Docket No. SA-537

Air Cruisers Service Bulletin 777 107-25-30

SERVICE BULLETIN REVISION NOTICE

EQUIPMENT FURNISHINGS - EMERGENCY EQUIPMENT 777 EVACUATION SLIDE/RAFT SYSTEMS INSPECTION AND REPLACEMENT OF PACKBOARD HOUSING ASSEMBLY

“SEALED” AND “UNSEALED” COMPONENTS
FIGURE 1

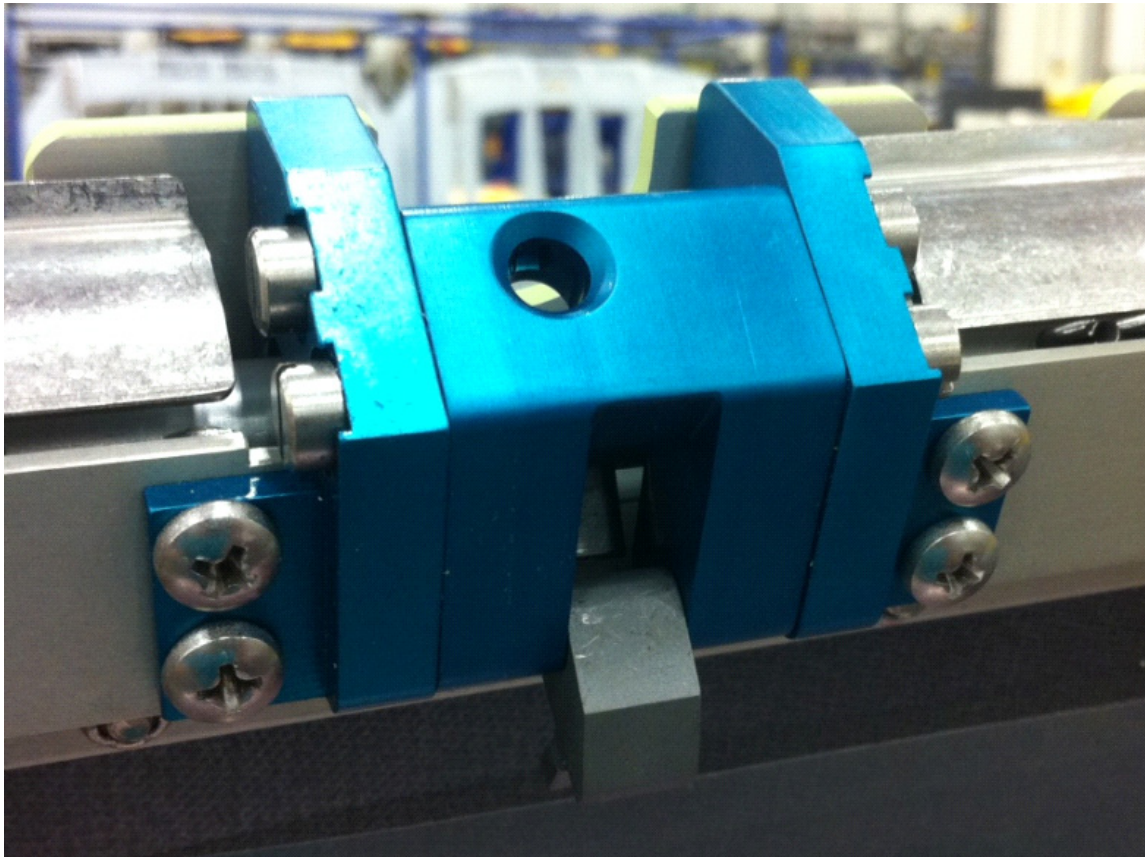
NOTE: Reference Figure 1 and 2 for differentiation between sealed and unsealed component colors.

In some instances, housing assemblies may have been provided with a combination of both sealed and unsealed components. In such cases, replacement of the housing assembly is required.

TYPE III “UNSEALED” ANODIZE
IDENTIFIED BY DARK FINISH

TYPE II “SEALED” ANODIZE
IDENTIFIED BY LIGHT, NATURAL FINISH

**NEW “BLUE” HOUSING ASSEMBLY P/N 68737-101
NO NEED TO REPLACE IF INSTALLED
FIGURE 2**

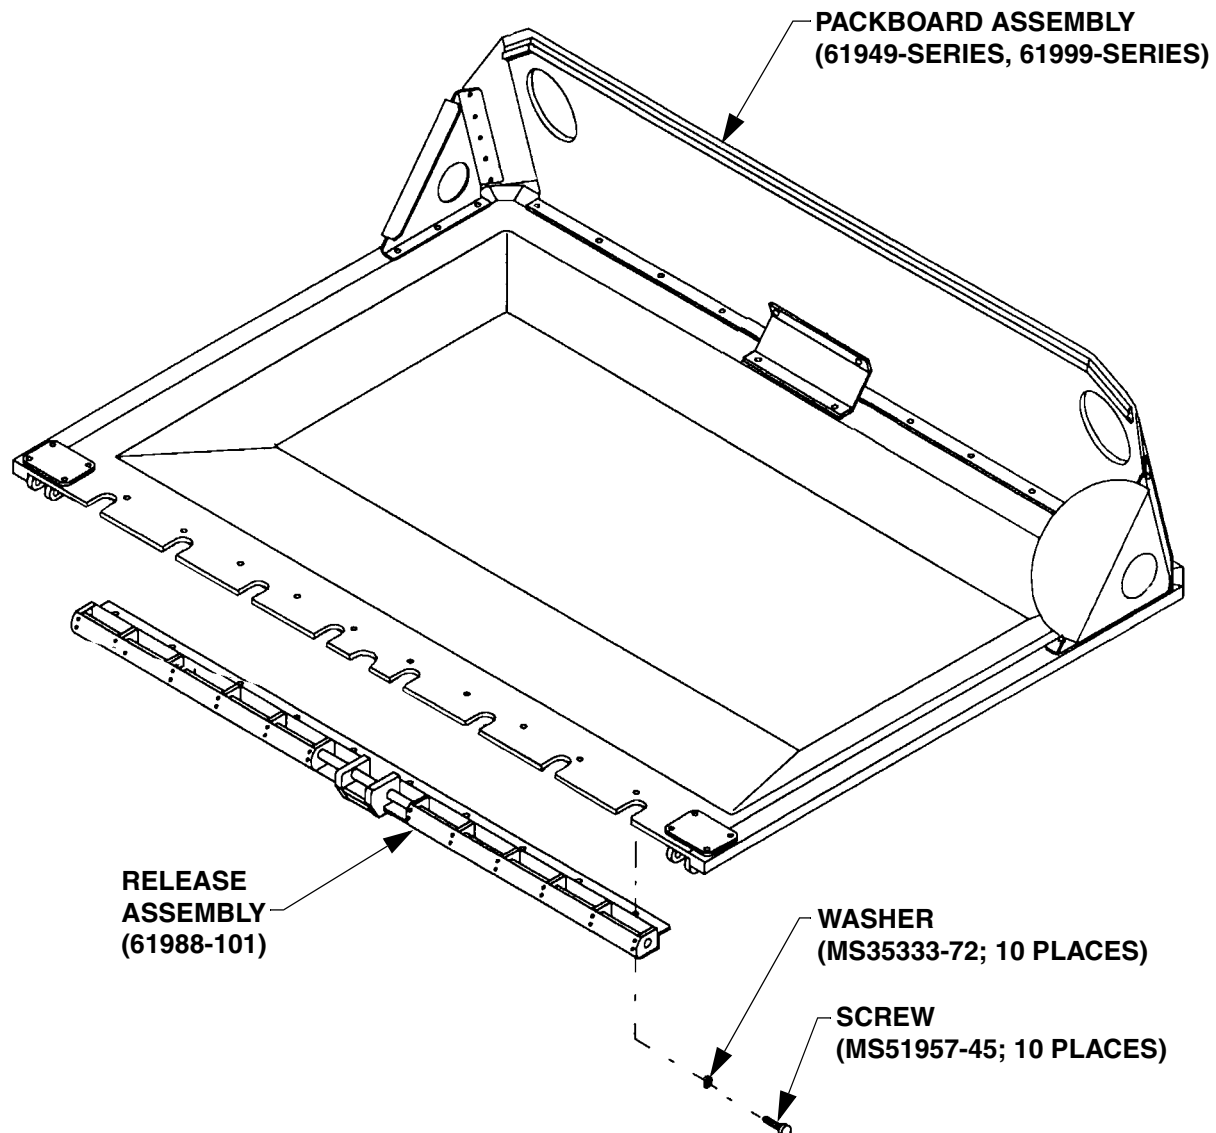
NOTE: The new housing assembly P/N 68737-101 is blue in color for easy identification. If this is installed, housing replacement is not necessary unless damage is evident.

NOTE: Variations in the shade of blue are typical and acceptable.

FIGURE 3

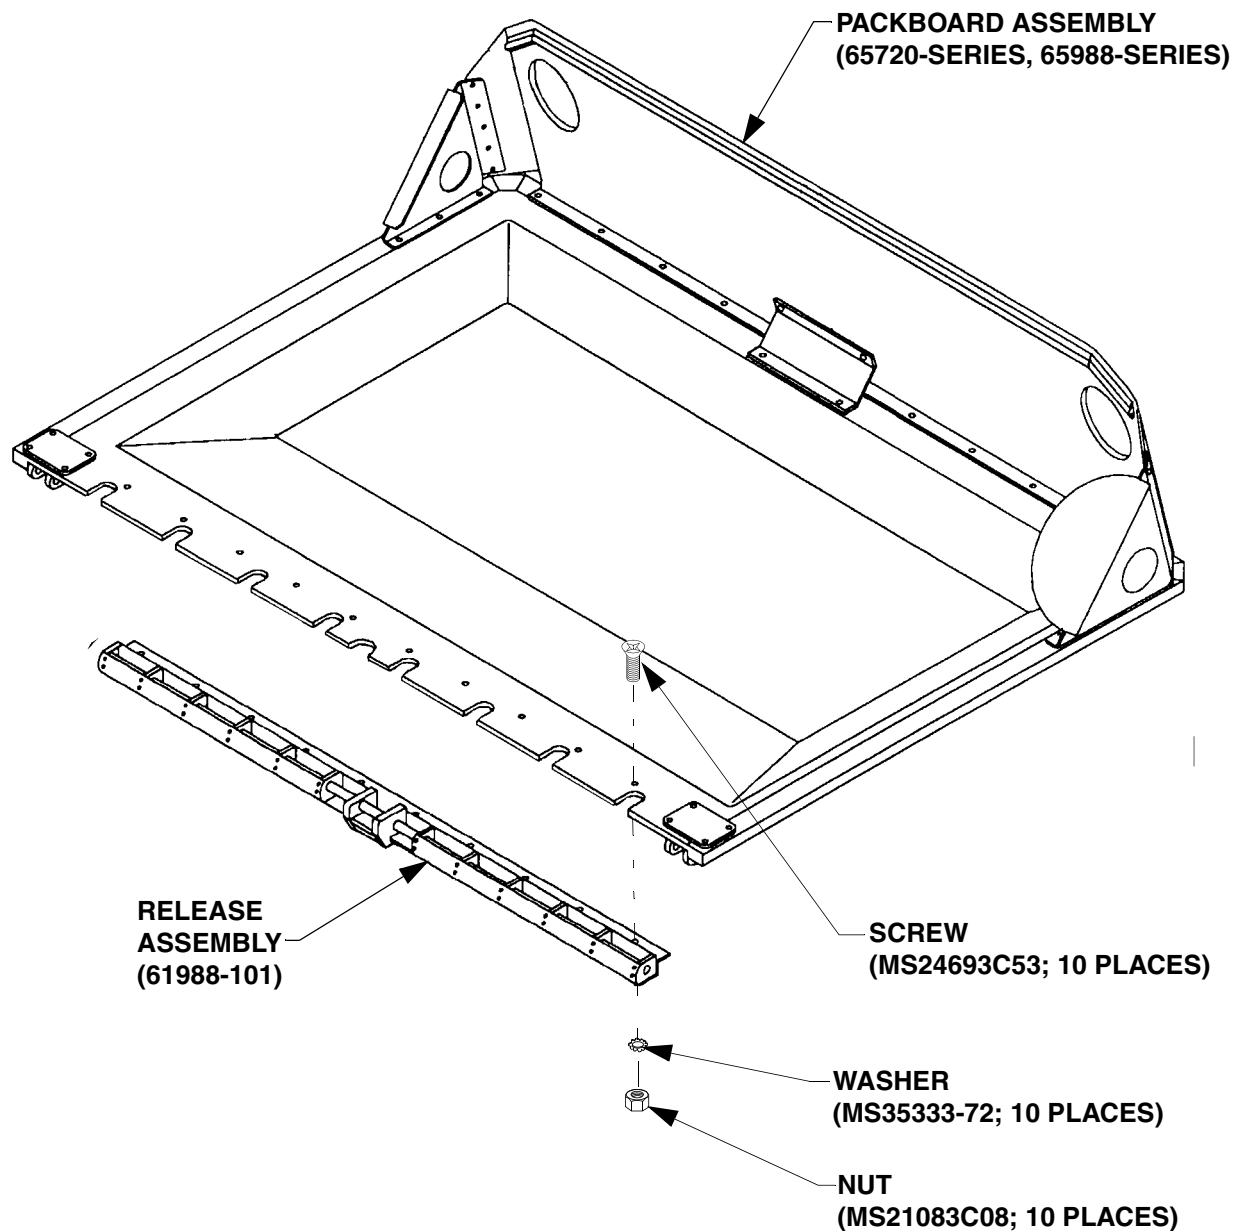
- A. If housing assembly replacement is necessary, for 61949-Series and 61999-Series packboards, remove the ten (10) screws (MS51957-45) and ten (10) washers (MS35333-72) that secure the release assembly (61988-101) to the packboard. Remove release assembly (61988-101) from the packboard. Reference Figure 3.

- K. For 61949-Series or 61999-Series packboards, install release assembly (61988-101) onto packboard using ten (10) existing screws (MS51957-45) and ten (10) existing washers (MS35333-72). Reference Figure 3.
For 65720-Series and 65988-Series packboards, install release assembly (61988-101 or 61988-103) onto packboard using ten (10) existing screws (MS24693C53), ten (10) existing washers (MS35333-72), and ten (10) new nuts (MS21083C08). Reference Figure 3.

FIGURE 4

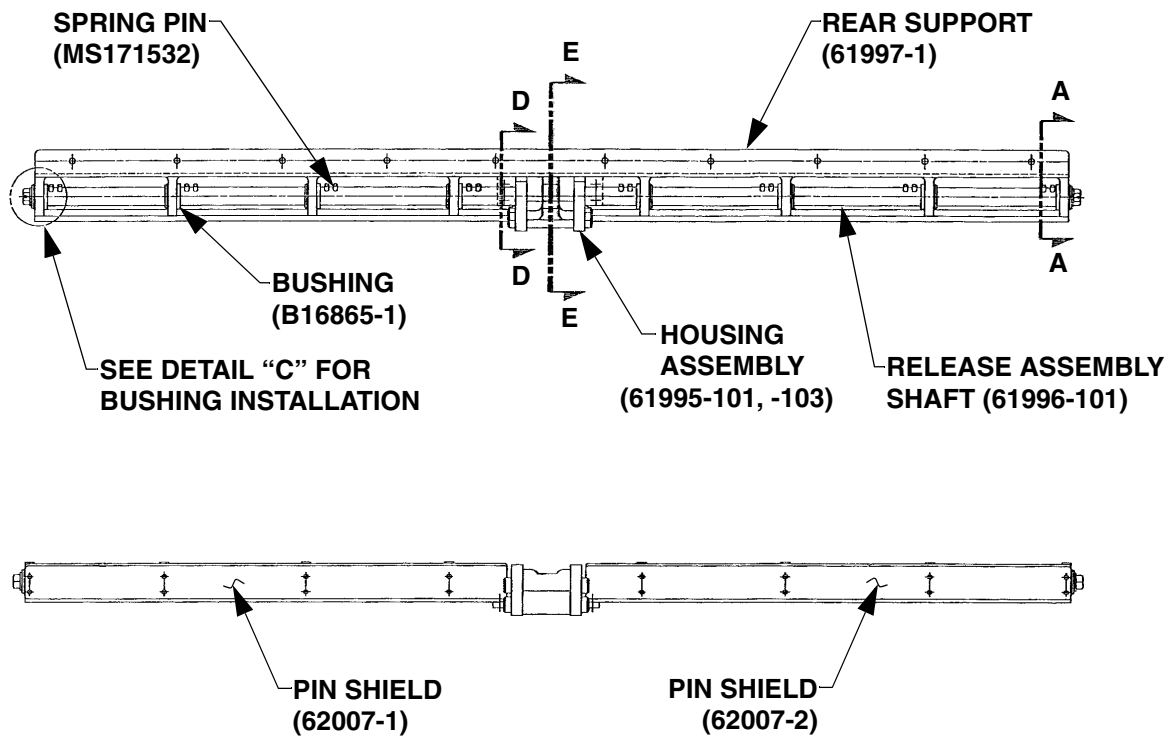
For 65720-Series and 65988-Series packboards, remove the ten (10) screws (MS24693C53), ten (10) washers (MS35333-72), and ten (10) nuts (MS21083C08) that secure the release assembly (61988-101 or 61988-103) to the packboard. Remove release assembly (61988-101 or 61988-103) from the packboard. Discard nuts (MS21083C08). Reference Figure 4.

RELEASE ASSEMBLY
FIGURE 5

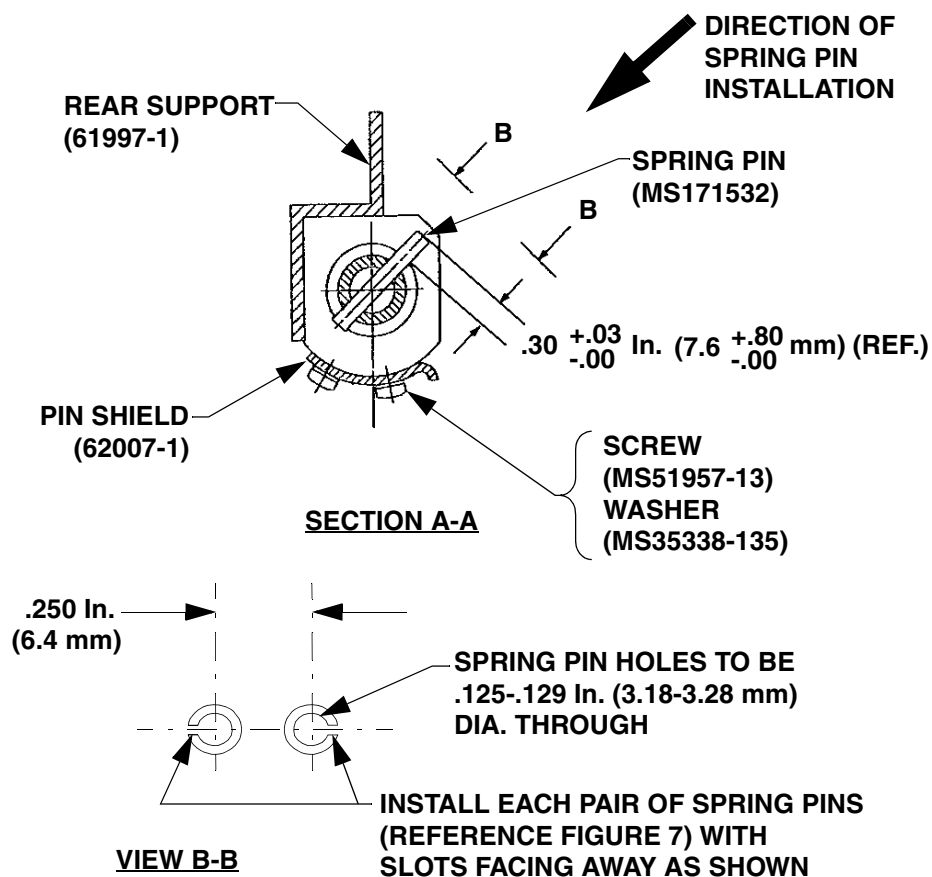
- B. Remove and discard sixteen (16) screws (MS51957-13) and sixteen (16) washers (MS35338-135) that secure each pin shield (62007-1, 62007-2) to the rear support (61997-1). Reference Figures 5 and 6, Section A-A.
- C. Remove and discard the spring pin (MS171496) that is used to secure the tang (62006-1) to the release assembly shaft (61996-101). Reference Figures 5 and 7, Section E-E.

- (1). To remove the spring pin, use a hammer and punch to start the pin out of the shaft, then use pliers to pull the pin free from the shaft.
- D. Remove and discard the remaining sixteen (16) spring pins (MS171532) from the release assembly shaft (61996-101). Reference Figure 5.

- J. Install pin shields (62007-1, 62007-2) onto rear support (61997-1) using sixteen (16) new screws (MS51957-13) and sixteen (16) new washers (MS35338-135). Reference Figures 5 and 6, Section A-A.

**RELEASE ASSEMBLY
FIGURE 6**

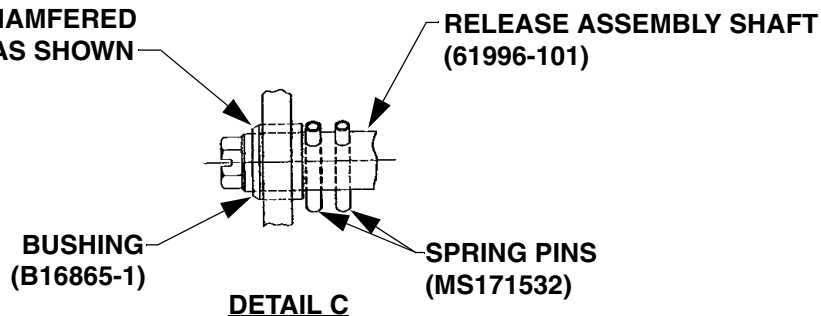
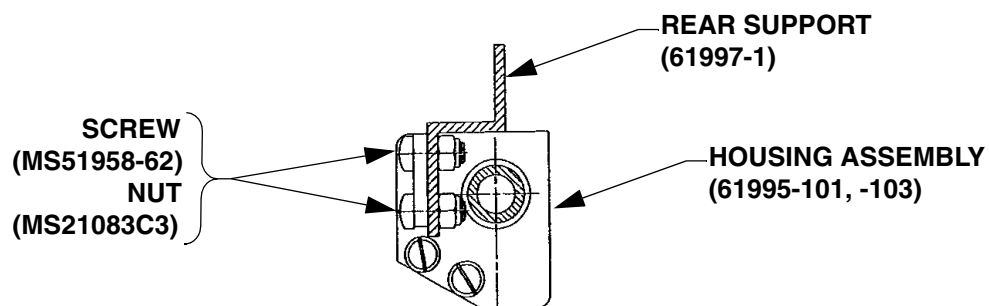
CAUTION: IF ANY OF THE SPRING PIN HOLES IN THE RELEASE ASSEMBLY SHAFT ARE ENLARGED OR DAMAGED WHILE REMOVING THE SPRING PINS, THE RELEASE ASSEMBLY SHAFT SHALL BE DISCARDED AND REPLACED. REFERENCE FIGURE 6.

NOTE: Ensure the eight (8) bushings (B16865-1) are properly installed in the rear support (61996-101). Reference Figure 6.

NOTE: Slots in spring pins shall be oriented outward. Reference Figure 6.

- H. Install release assembly shaft (61996-101) into rear support (61997-1) and install sixteen (16) new spring pins (MS171532) using pin set tool 68756-1 and hammer. Reference Figures 6 and 8.
- I. Install tang (62006-1) into release assembly shaft (61996-101) using new spring pin (MS171496). Reference Figure 7.

BUSHING INSTALLED IN SHAFT
SUPPORT WITH CHAMFERED
END FACING OUT AS SHOWN

**RELEASE ASSEMBLY
FIGURE 7**

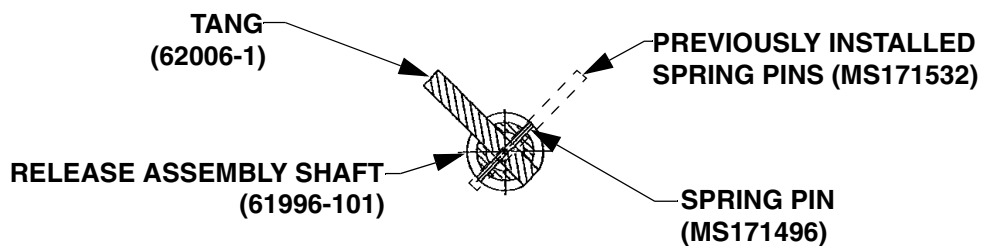
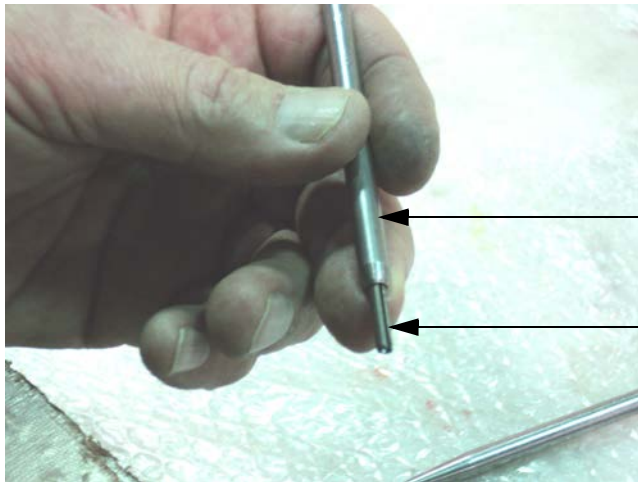
- (1). To remove the spring pins, use a hammer and punch to start each pin out of the shaft, then use pliers to pull each pin free from the shaft.
- E. Slide the release assembly shaft (61996-101) out of the rear support (61997-1). Reference Figure 4.
- F. Remove the four (4) screws (MS51958-62) and four (4) nuts (MS21083C3) that secure the housing assembly (61995-101) to the rear support (61997-1) and remove the housing assembly from the rear support. Discard nuts (MS21083C3). Reference Figure 7.
- G. Install new housing assembly (68737-101) onto the rear support (61997-1) using four (4) existing screws (MS51958-62) and four (4) new nuts (MS21083C3). Reference Figure 7.

SPRING PIN (MS171532) INSTALLATION
FIGURE 8

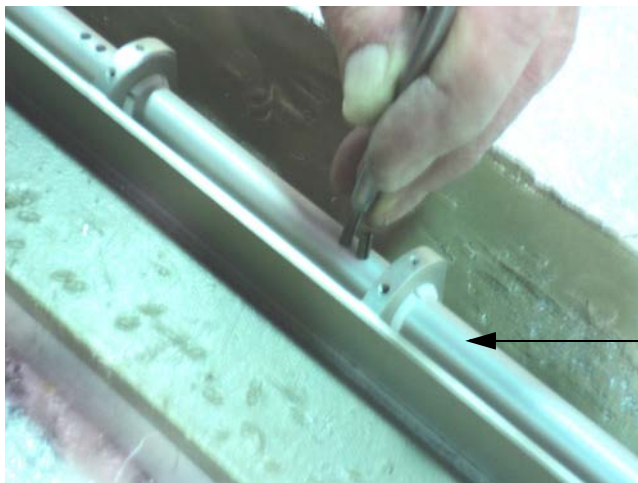
1. INSERT SPRING PIN (MS171532)
INTO PIN SET TOOL AS SHOWN

2. GUIDE SPRING PIN (MS171532) INTO
HOLE OF RELEASE ASSEMBLY
SHAFT (61996-101)

3. TAP PIN SET TOOL WITH HAMMER
UNTIL TOOL COMES IN CONTACT
WITH RELEASE ASSEMBLY SHAFT
